# ADDENDUM NO. 1

**DATE:** October 5, 2011  
**TO:** All Plan Holders  
**FROM:** John R. Sawyer  
**PROJECT:** **JACKSONVILLE CITY HALL: EXTERIOR ENVELOPE  
BUILDING RENOVATION**  
Jacksonville, NC

Jacksonville  
City Hall  
Exterior  
Envelope  
Renovation

Addendum #1

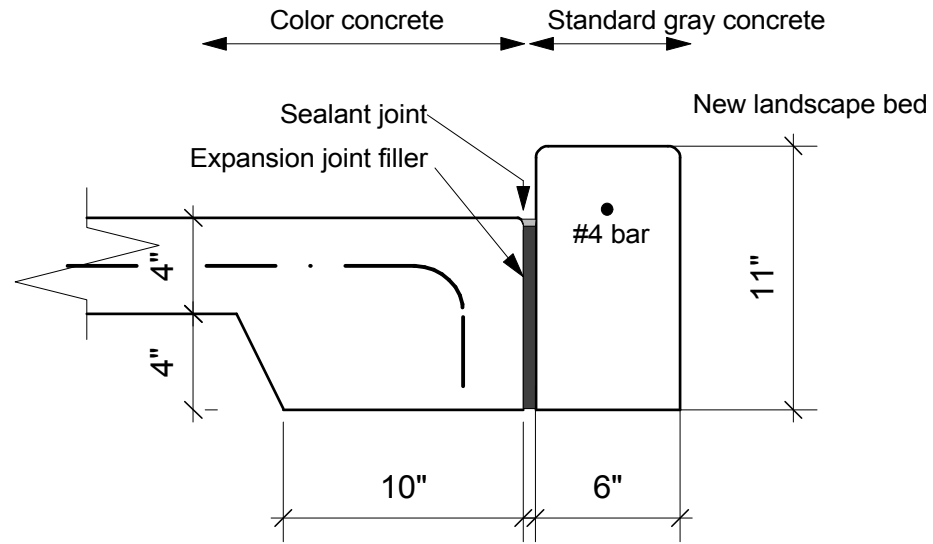
- b. A new landscape plant bed is shown on this plan and noted as “Landscaping by Owner”. A slab edge detail is AB-1, which will apply at all new cast-in-place concrete walkways bordering this landscaped area.

Provide expansion control joints in landscape curb edge  
to align with walkway joints

**AB-2**  
of  
1 Sheets

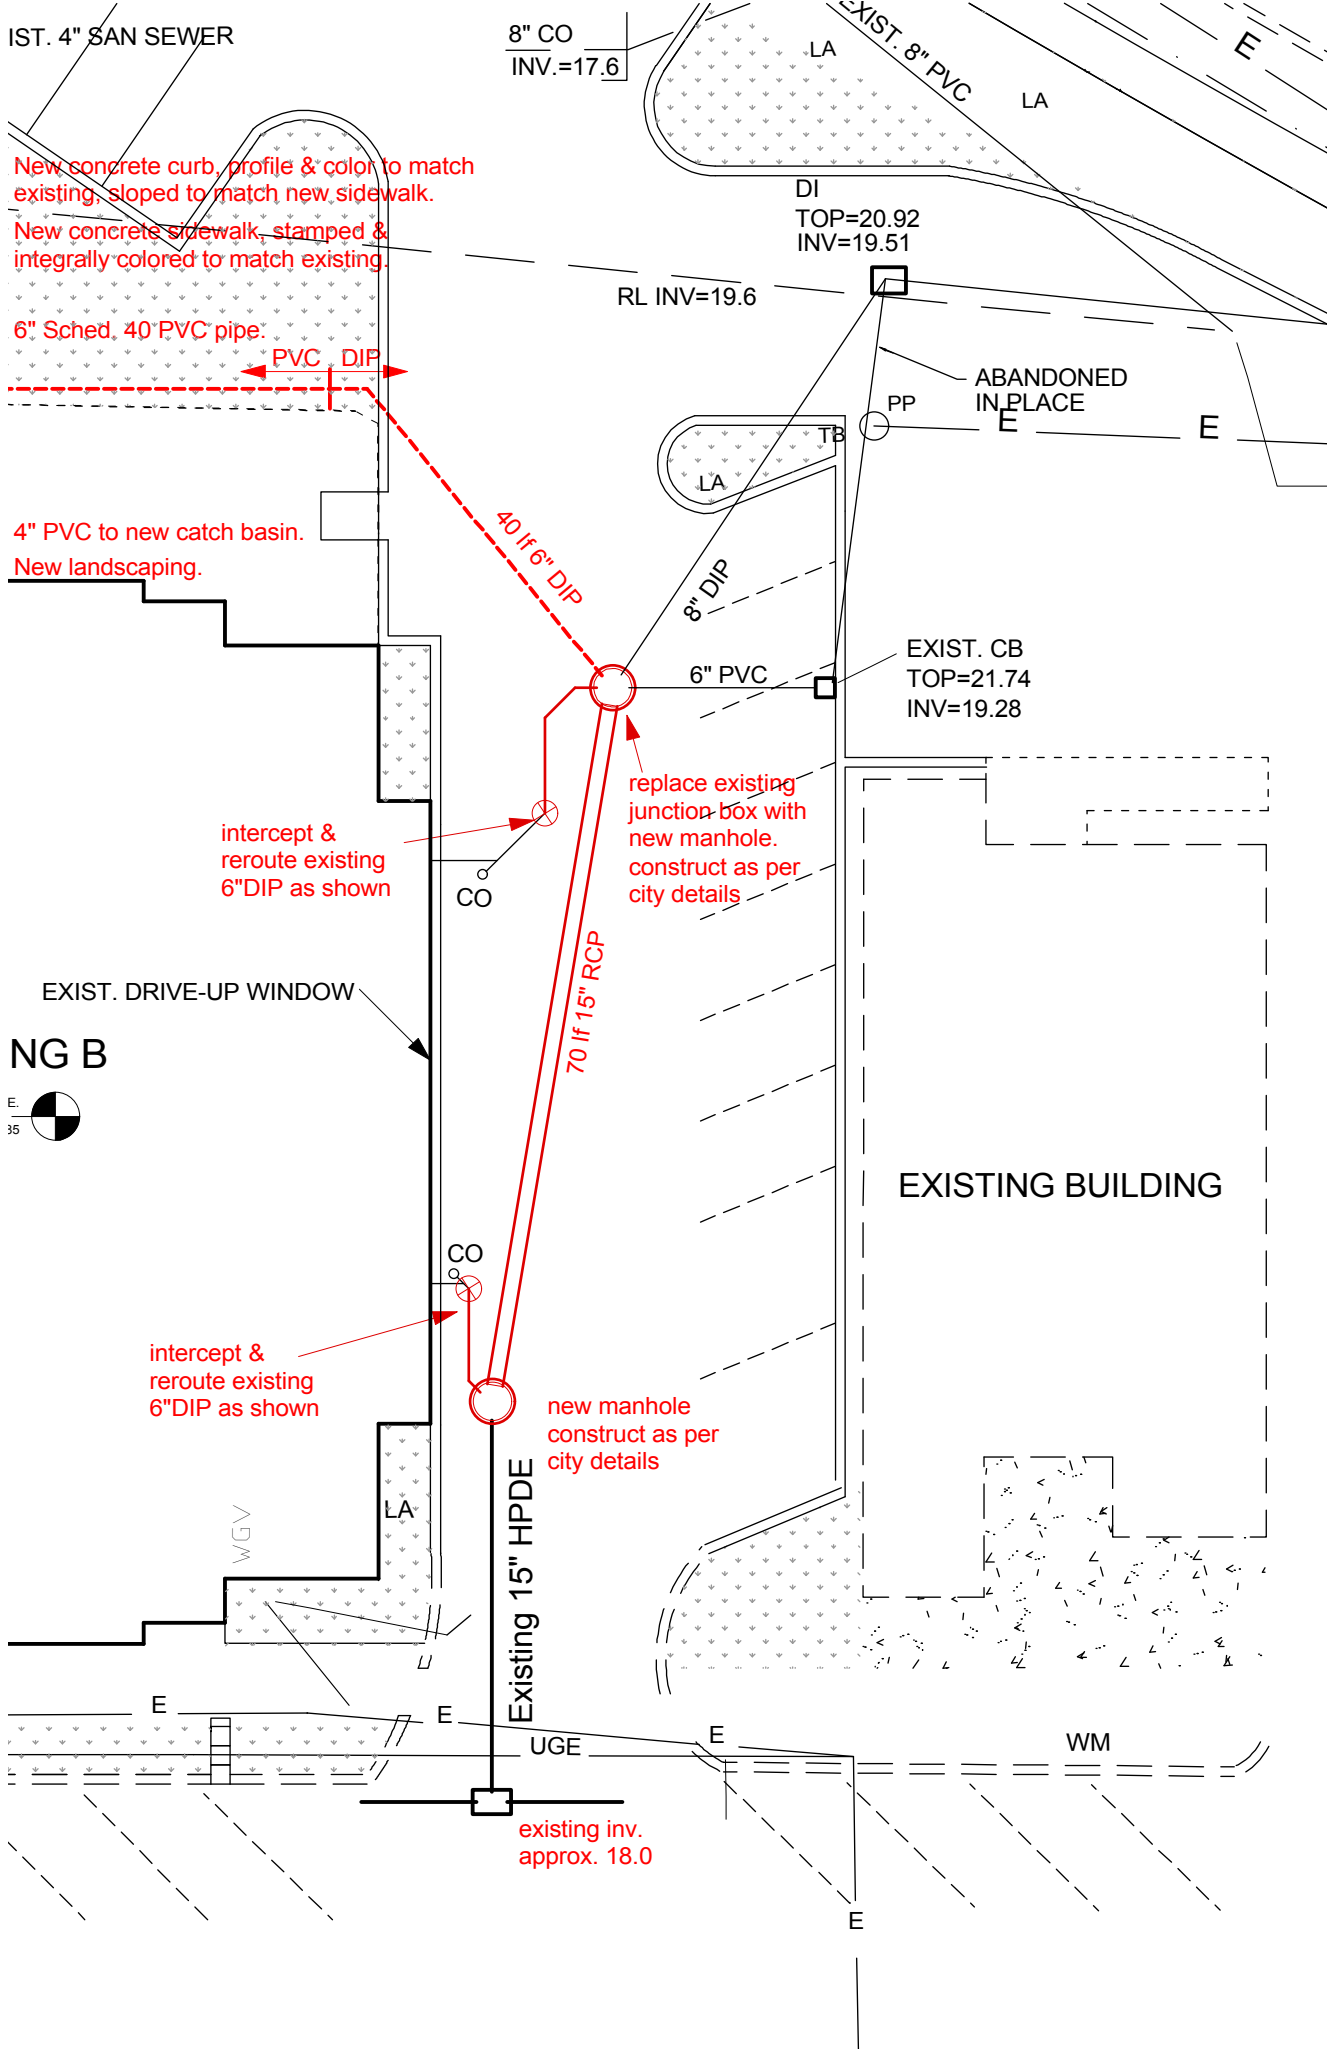
- c. Revised drawing AB-2 is enclosed adding 2 manholes and storm drainage piping indicating changes in the connection of drainage to the existing storm drain system.

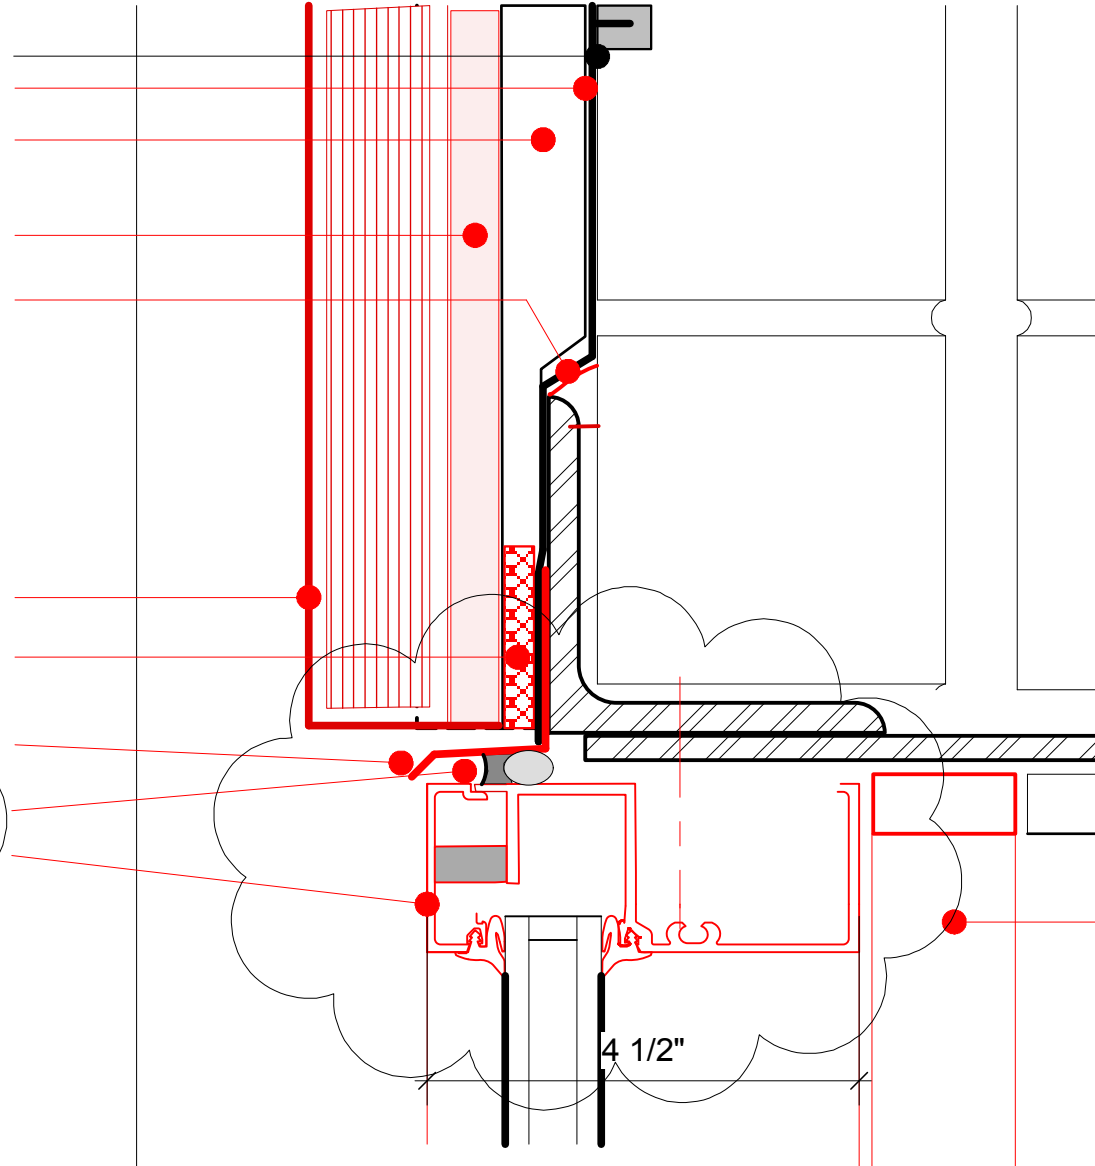
4. Sheet A-4.1:
  - a. Detail 2: The head flashing has been revised; drawing AB-3 is attached.
  - b. Detail 2 and Detail 5: the filler strip indicated at the jambs and head is gypsum drywall, which is to be finished and painted.

Provide composite wood 5/4 x 3 furring - Cope back side for existing lintels. Furring to run vertically, space 16" O.C.

New 1/2" cementitious fiber-mat reinforced backer board.

New copper laminated flashing set in saw-cut reglet.

Provide new shop fabricated 0.032" aluminum flashing.
